Application for Variation of an Environmental Permit

**Agreement No. CE 6/2015 (EP)
West New Territories (WENT)
Landfill Extension – Design and
Construction**

Supporting Document for Variation
of Environmental Permit

Drawing title
LANDFILL GAS CUT-OFF TRENCH BARRIER

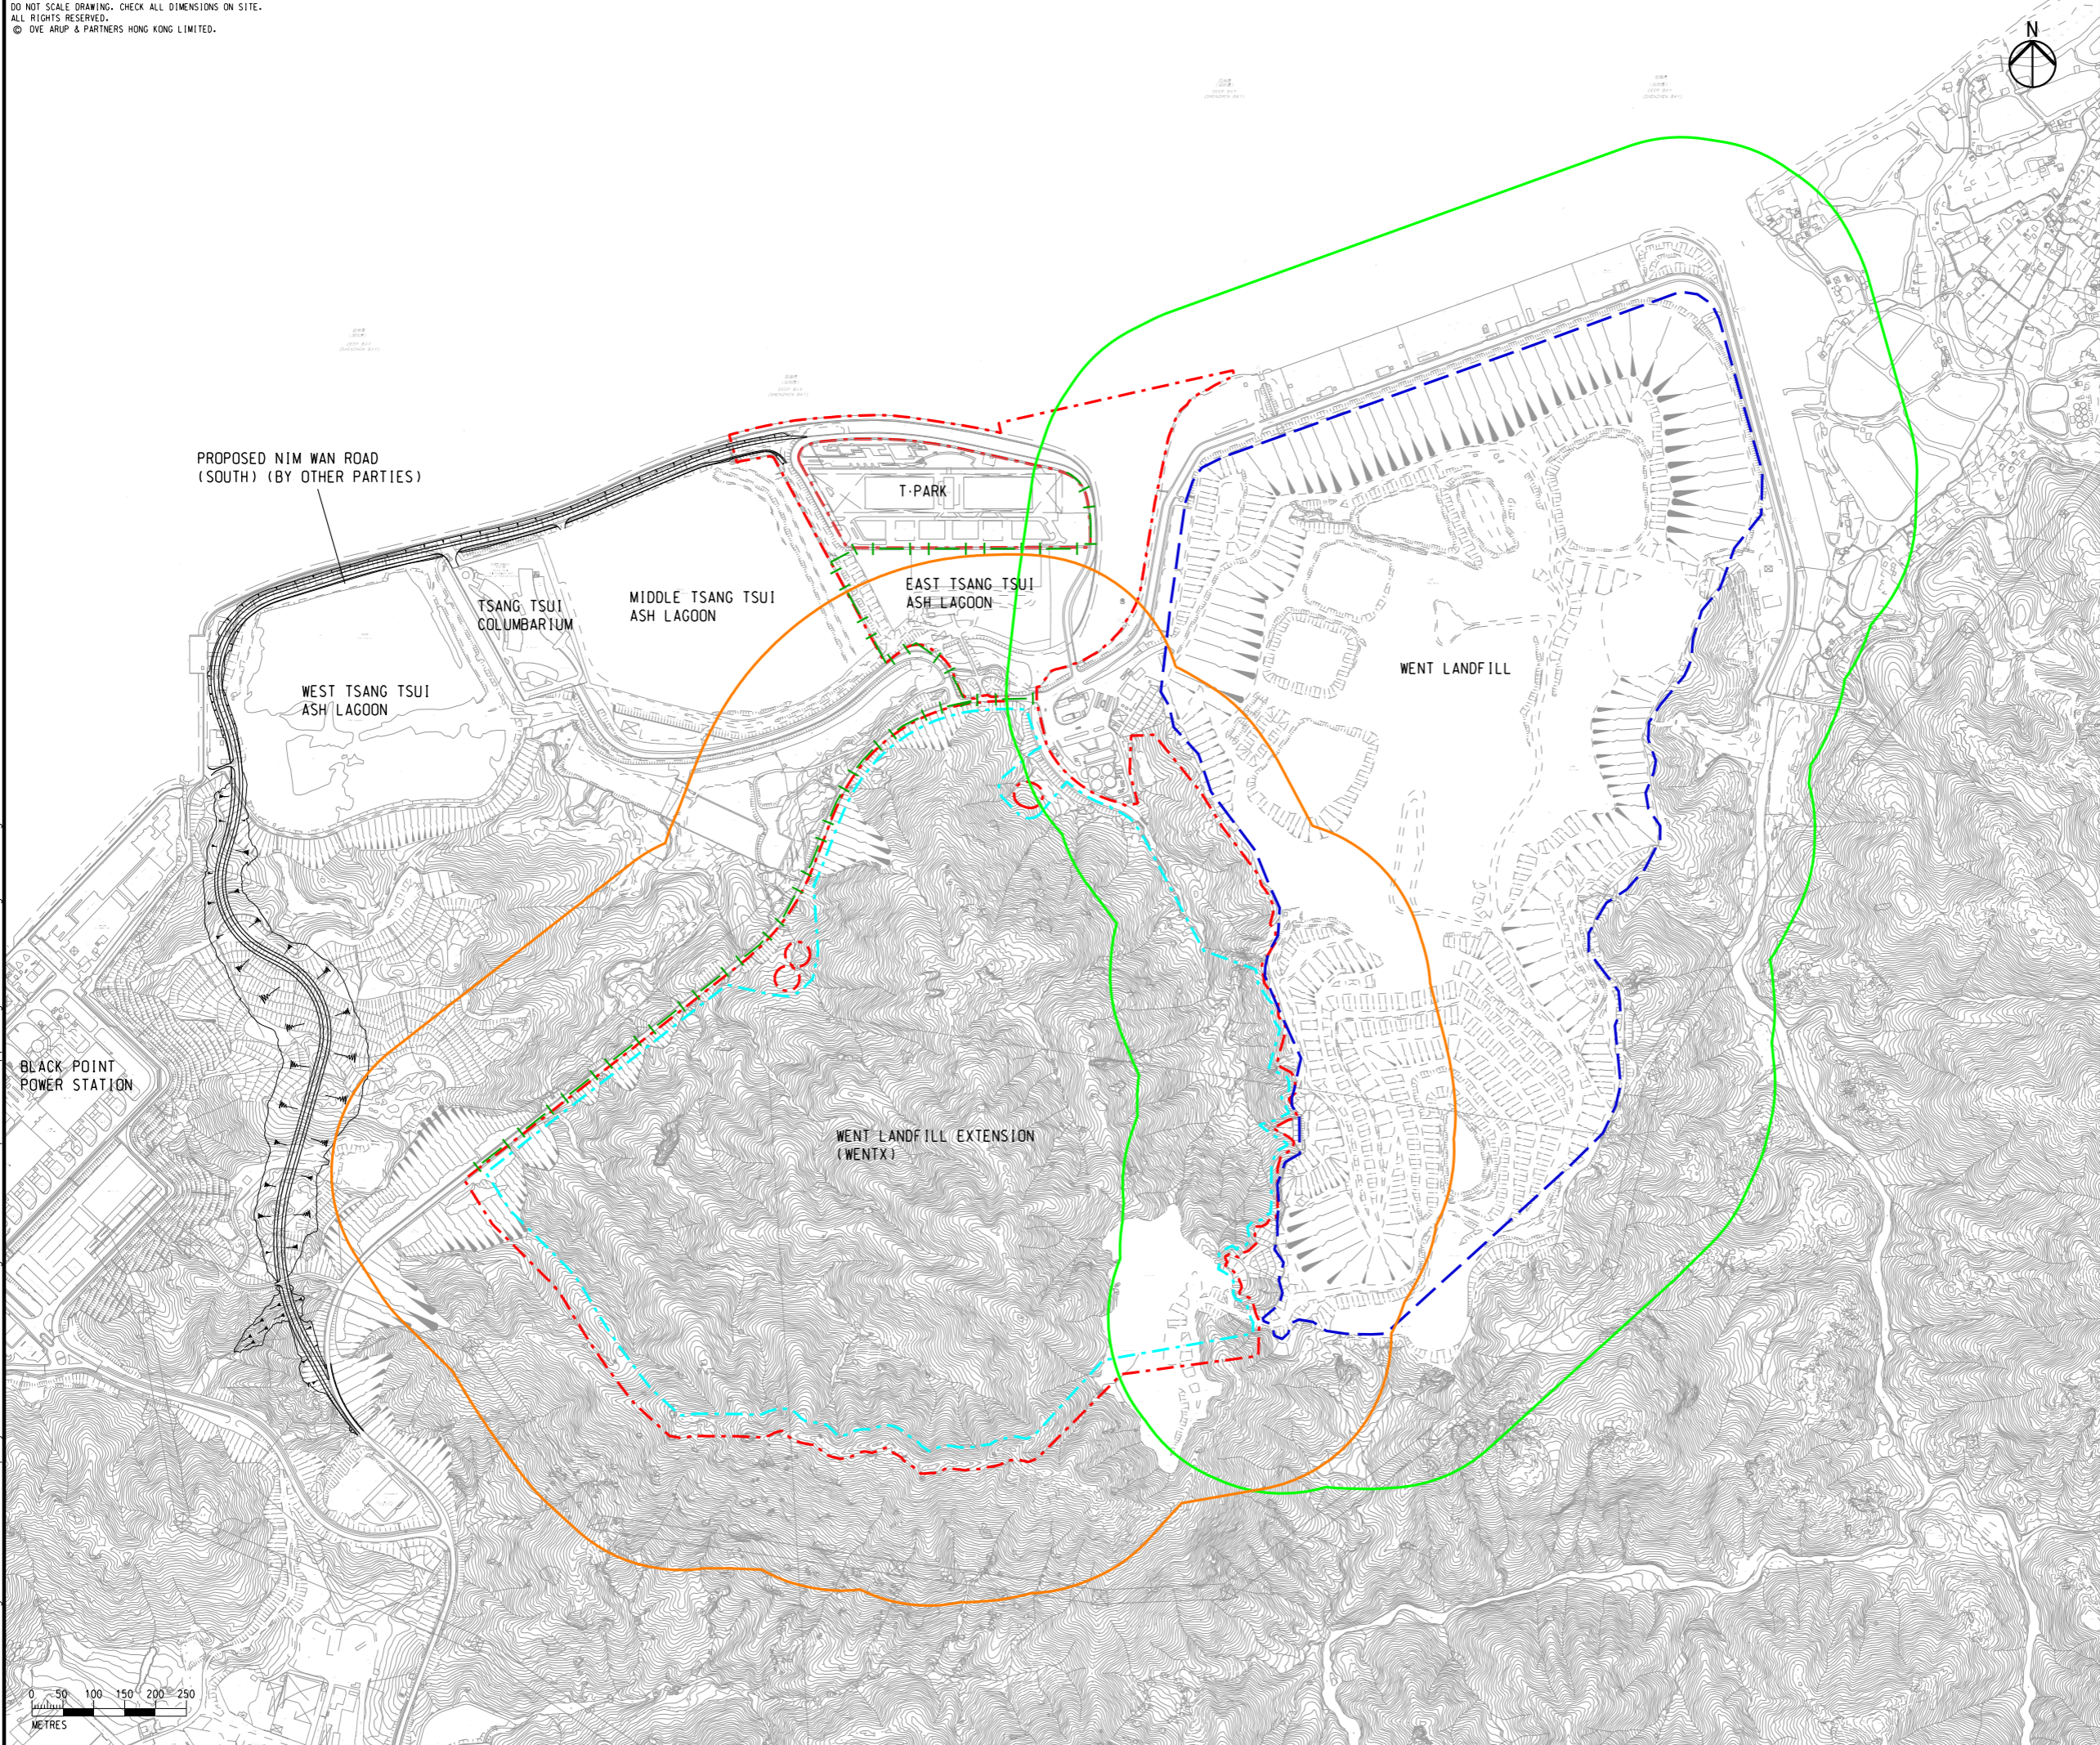
- 9.1.3** With the revised boundary of landfill site, the proposed liner and LFG cut-off trench barrier has been adjusted as illustrated in **Figure 9.2**. The monitoring requirements in the Original Scheme as recommended in the approved WENTX EIA are still valid and the monitoring locations have been updated for the revised boundary as shown in **Figure 9.3**, which are subject to changes depending on the design, phasing and modification by the contractor.

Drawing title
**LOCATION OF TSING TSUI
 ARCHAEOLOGICAL SITE
 AND BUILT HERITAGE**

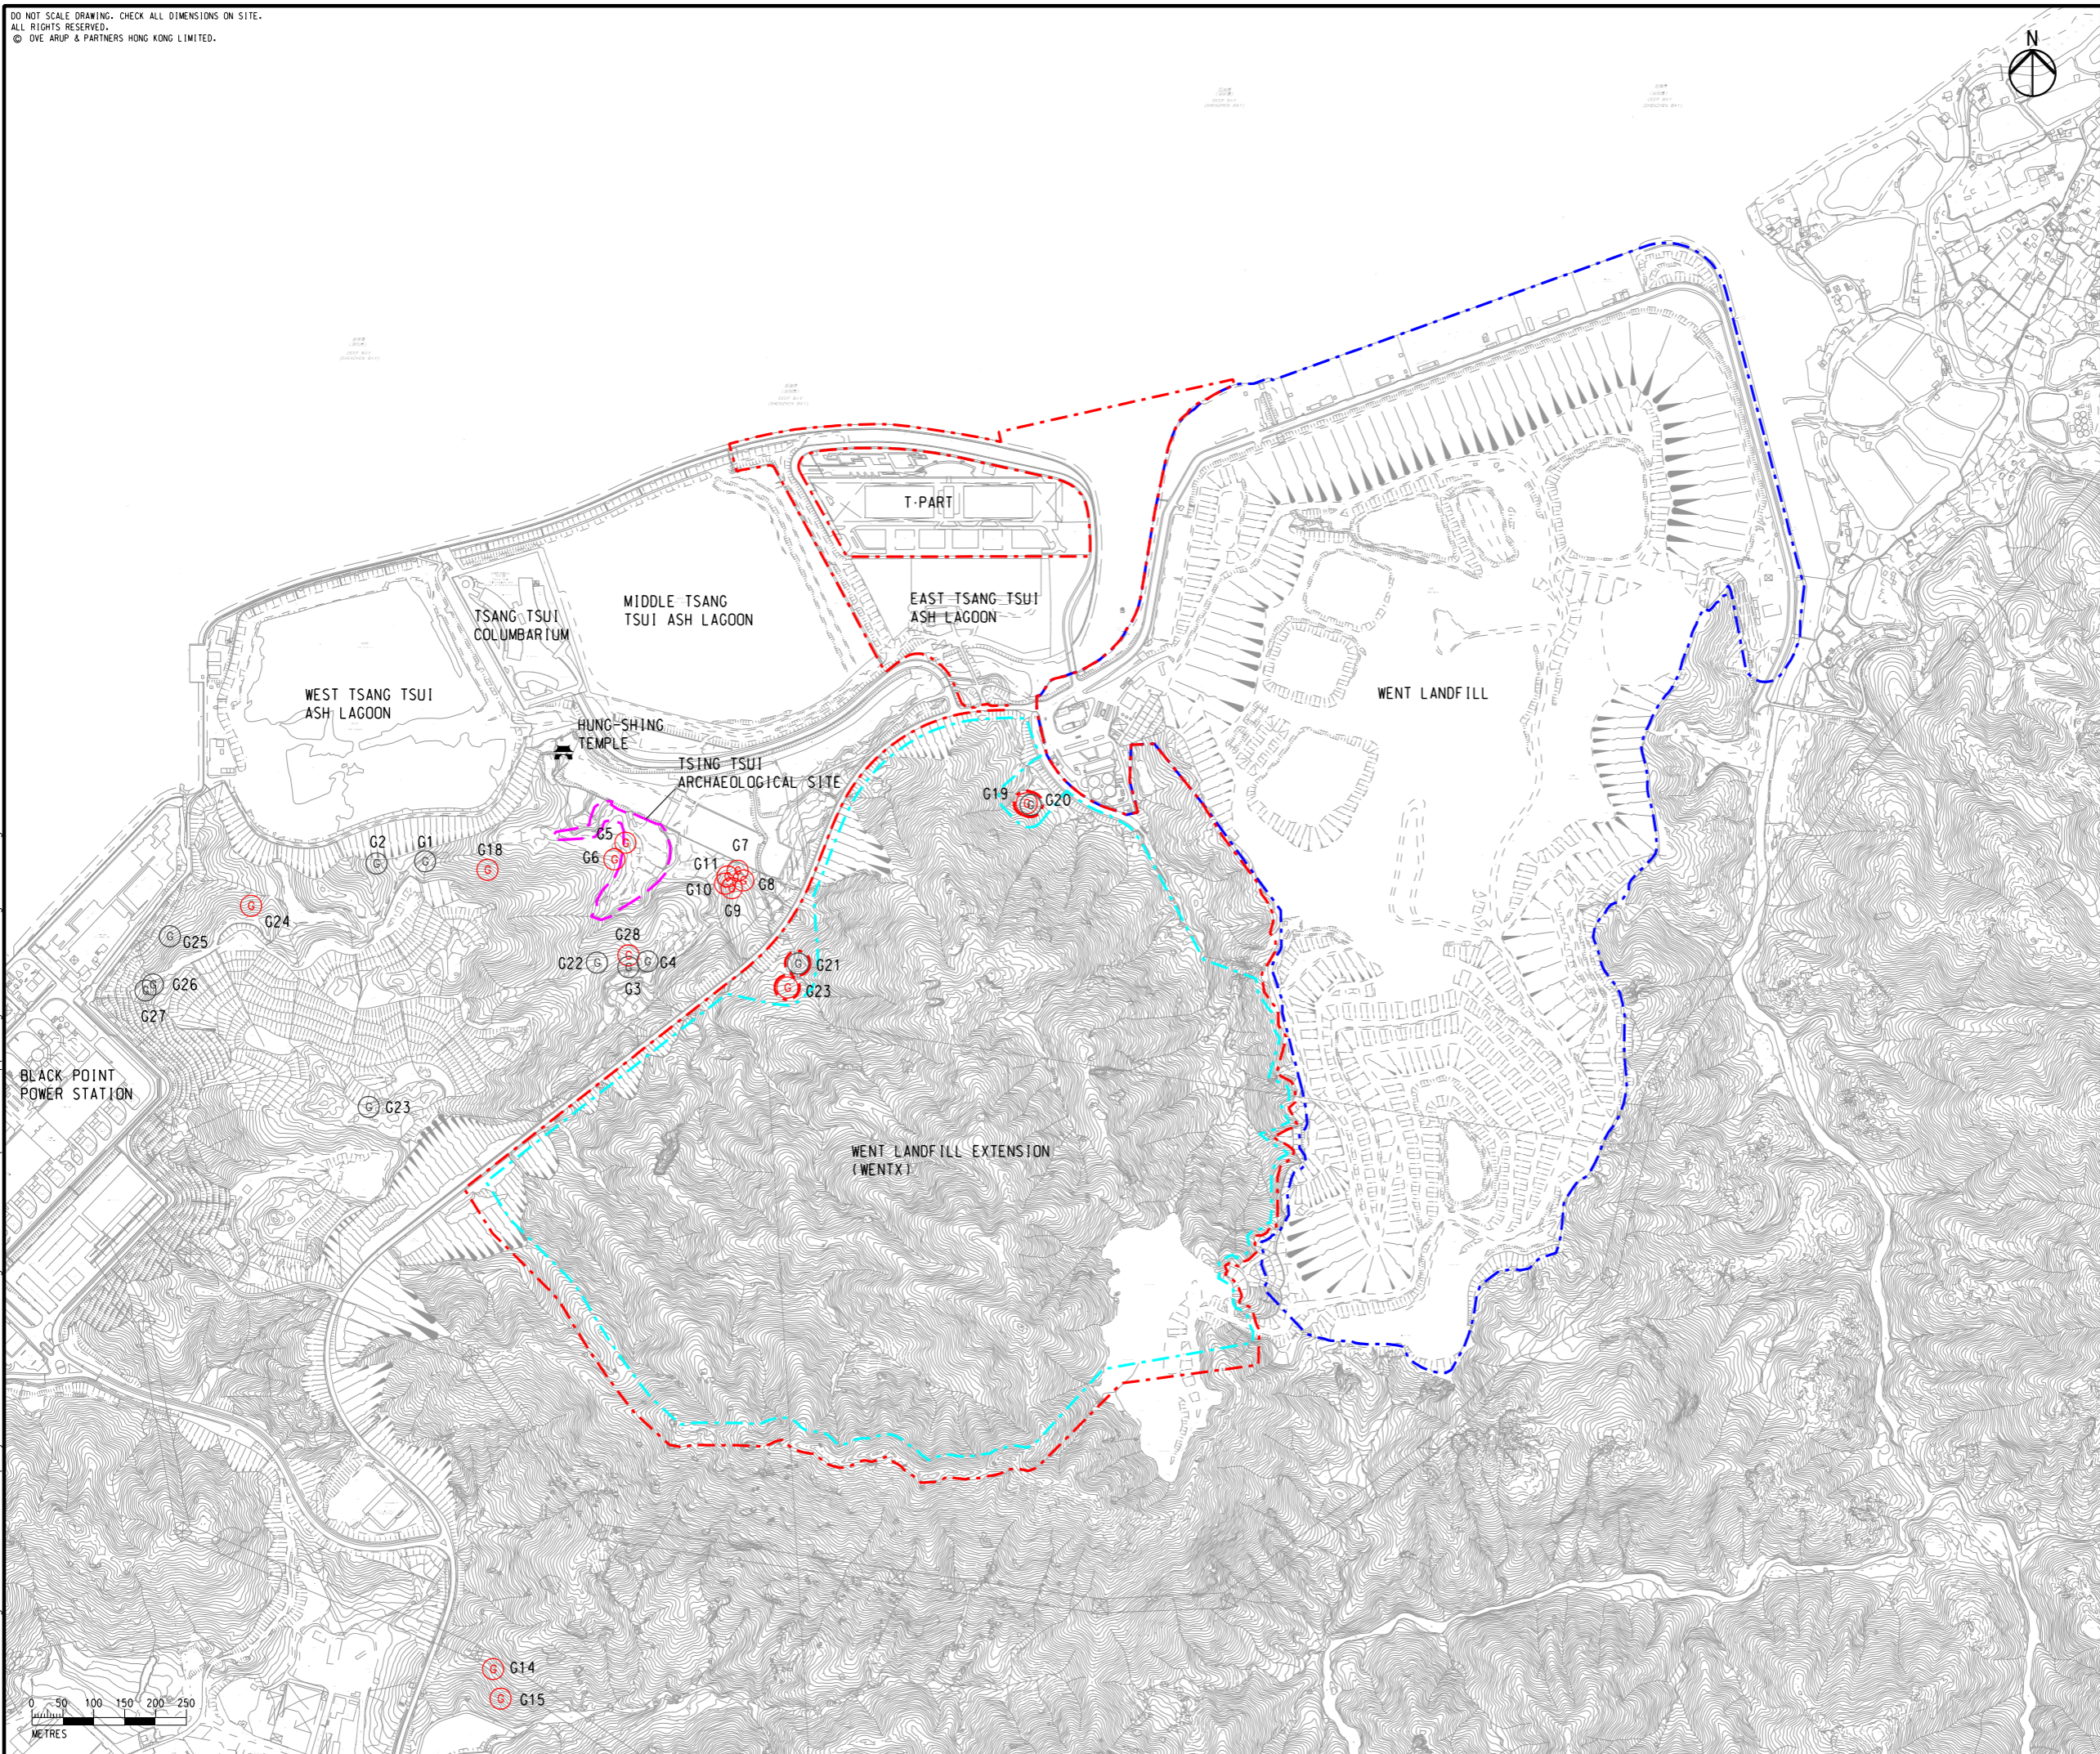
9.3.1 Under the Enhanced Scheme, the revised boundary will totally avoid encroachment onto the TTAS, graves and temple (**Figure 9.5**). No potential cultural heritage impact due to the Project is anticipated, and thus no mitigation measures are required for the Enhanced Scheme.

Drawing title
FIGURE 1 FOR VARIATIONS OF ENVIRONMENTAL PERMIT FOR WENT LANDFILL EXTENSION

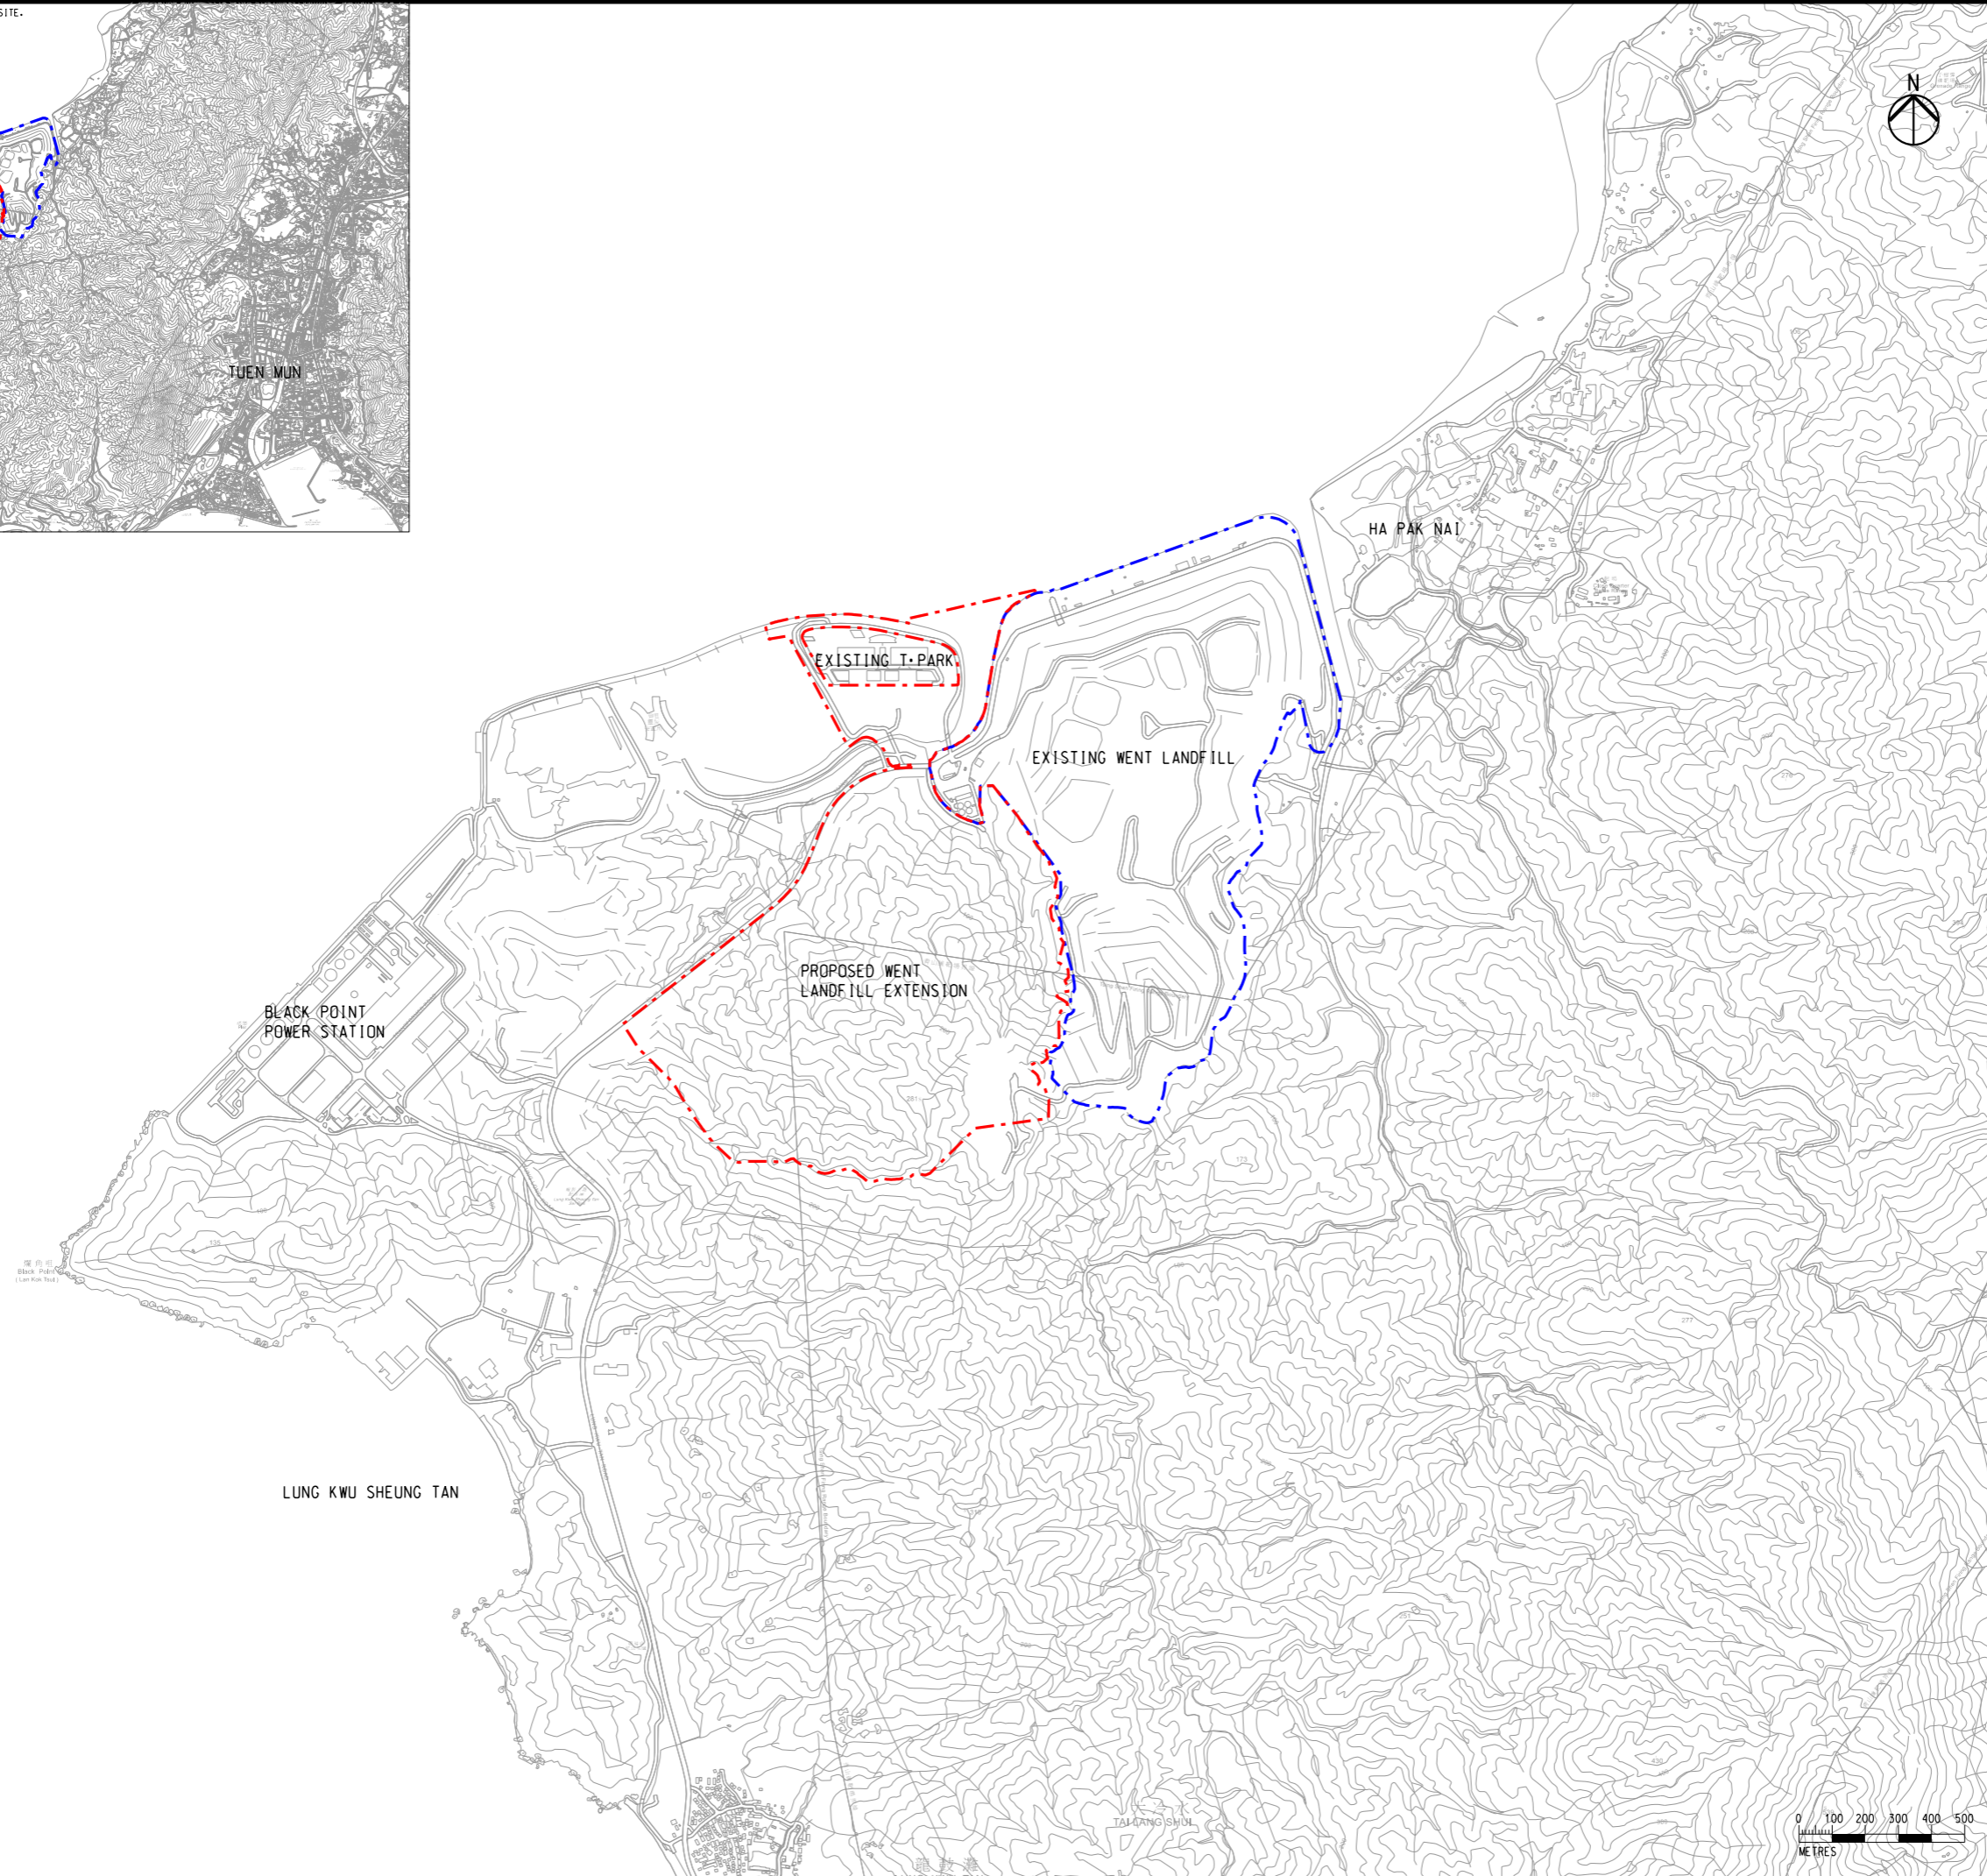
Figure 1	West New Territories (WENT) Landfill Extensions - Location Plan	See Figure 10.1 of this document	The WENTX boundary has been reduced in the Enhanced Scheme.
Figure 2	Cross-section of Freshwater Pond for Little Grebe	Add a note no. 9 to the figure: 9. Subsequent to the avoidance of encroachment of breeding habitat for Little Grebe in the Enhanced Scheme is revised landfill design, the above	The habitat creation of freshwater pond is not required, given that there is no loss of the breeding habitat for Little Grebe in the Enhanced Scheme.
